FORESTSIDE TOWNHOUSES

SITE INSTRUCTION # 6

JAP Project No: 19066

Issued for : ISSUED FOR SITE INSTRUCTION # 6

Date Plotted: **ND** Date: **Oct 06 2021**
Drawn By: **JW** Scale: **1 : 100**
Checked By: **JW** Revision Number:
Job No.: **19066** Sheet No.: **S-103B**

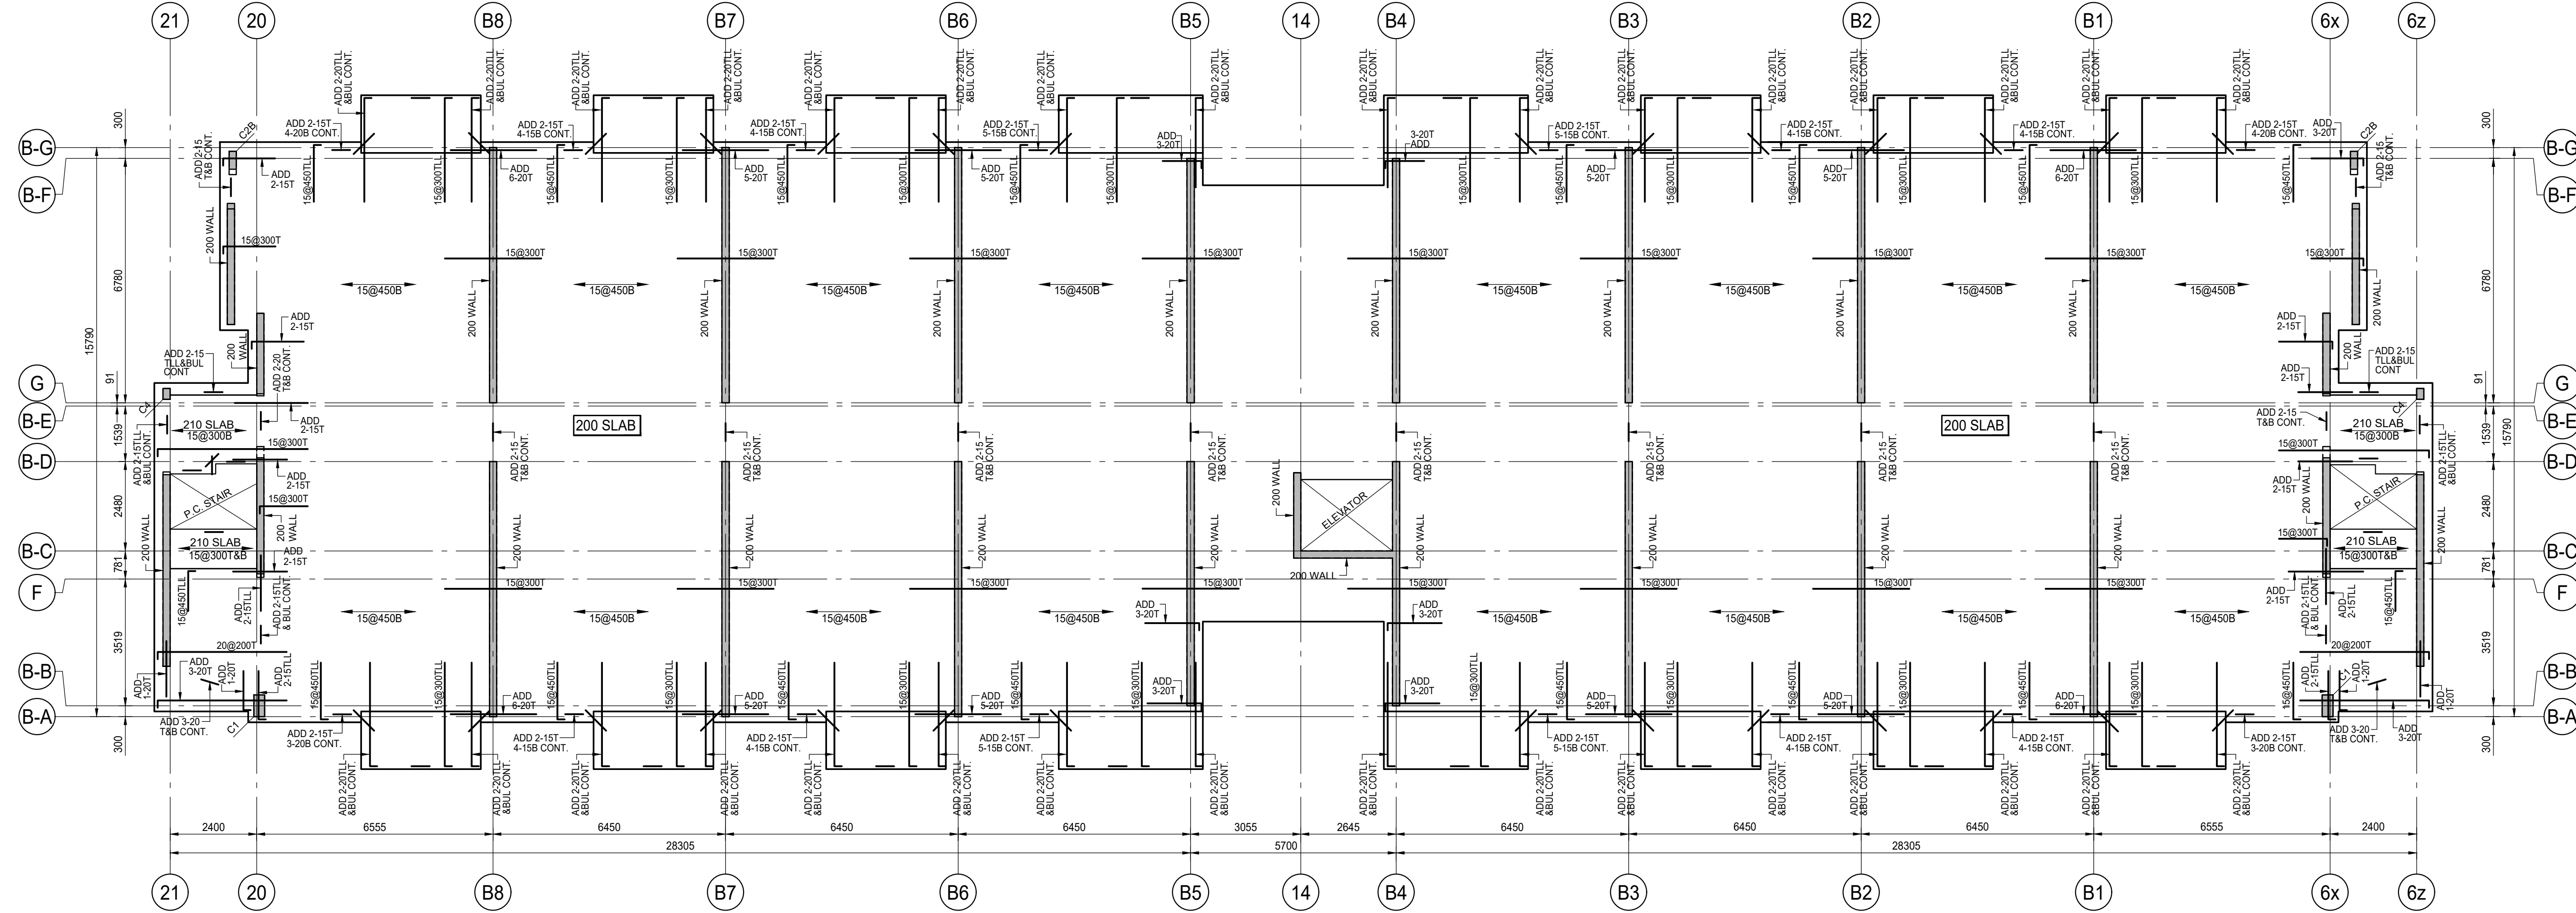
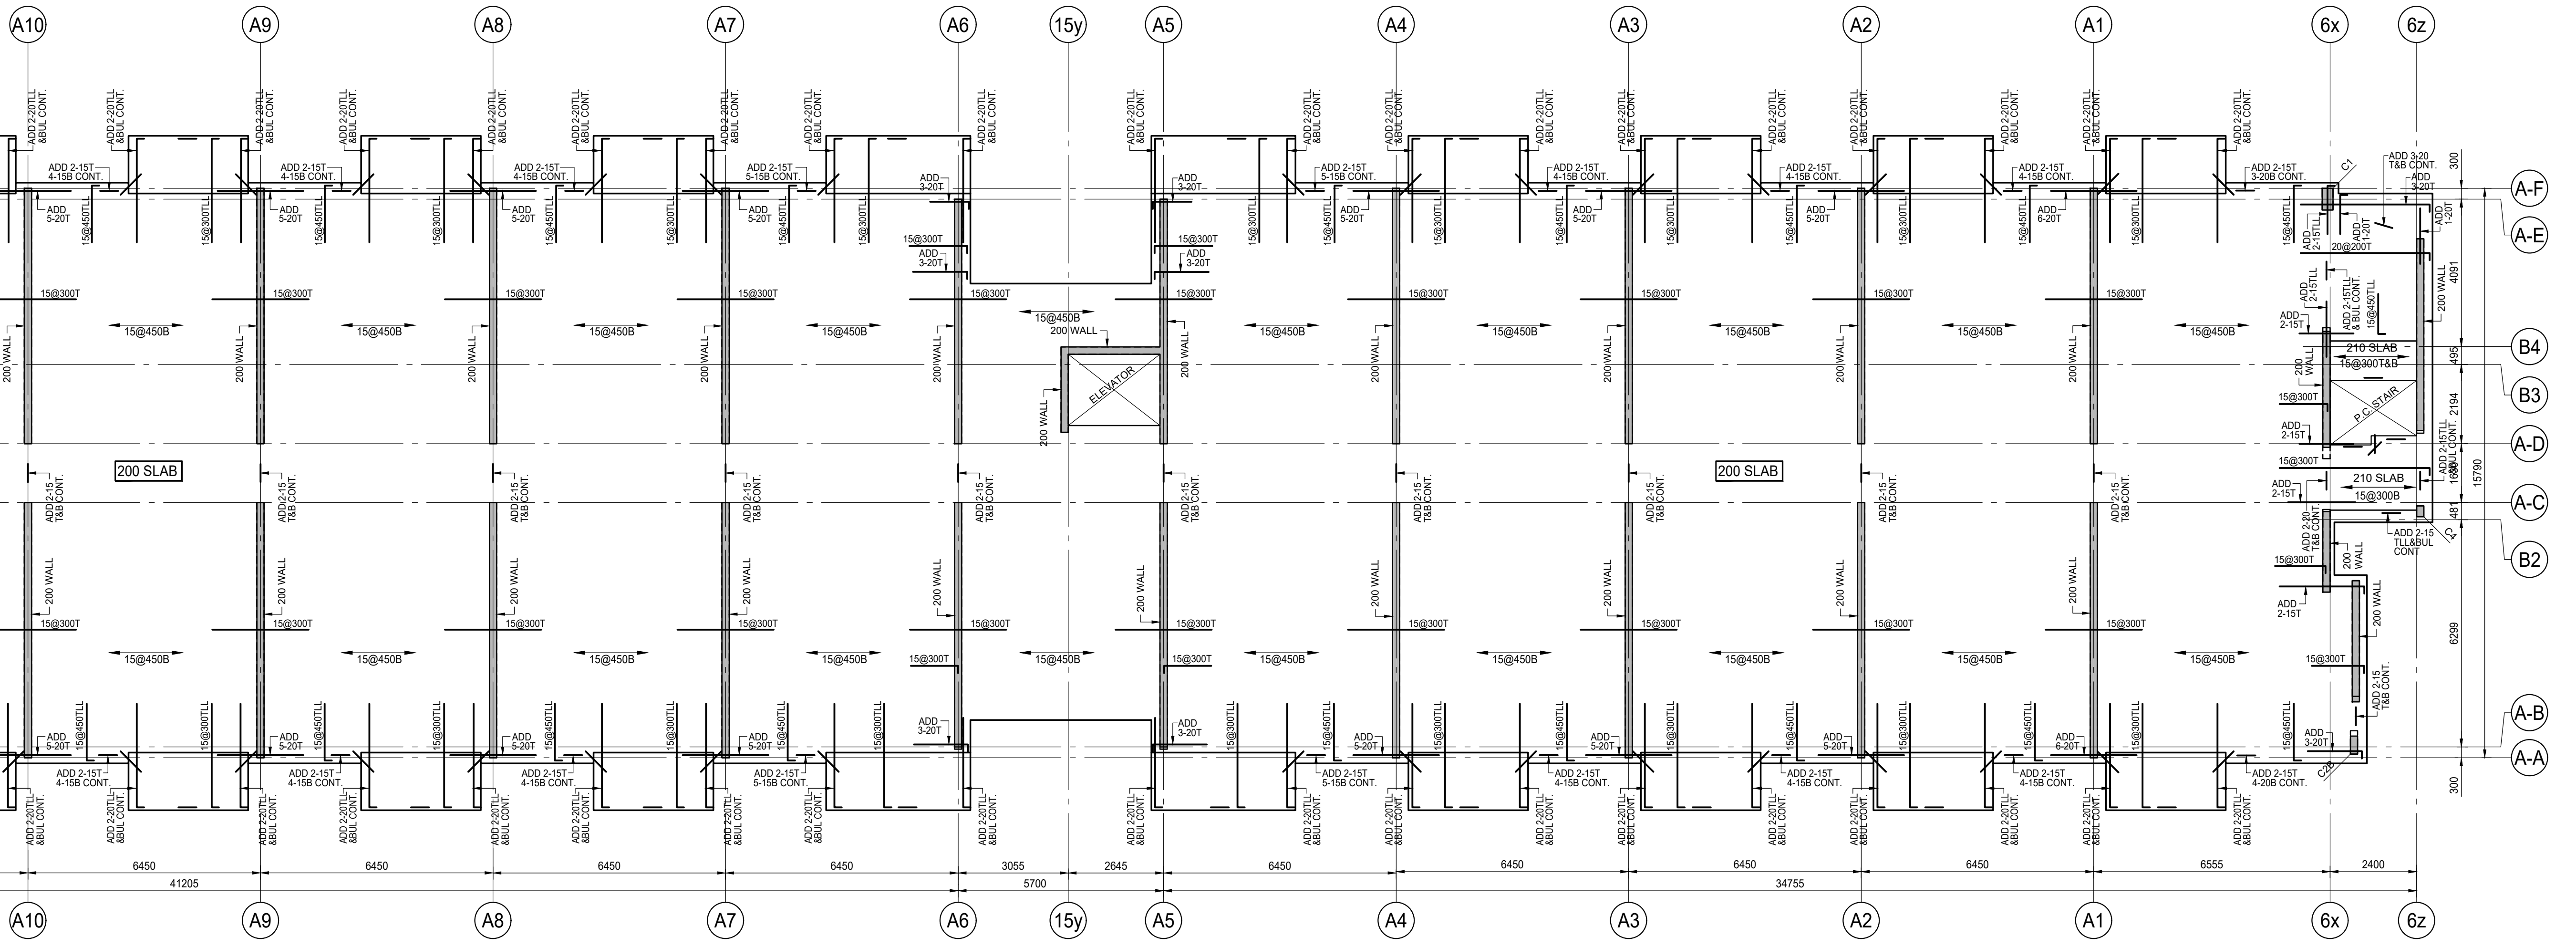
1.1 **Refer to Drawing S-103B "2ND FLOOR FRAMING PLAN"**

- a) Updated to match slab edge to add canopies on Building C
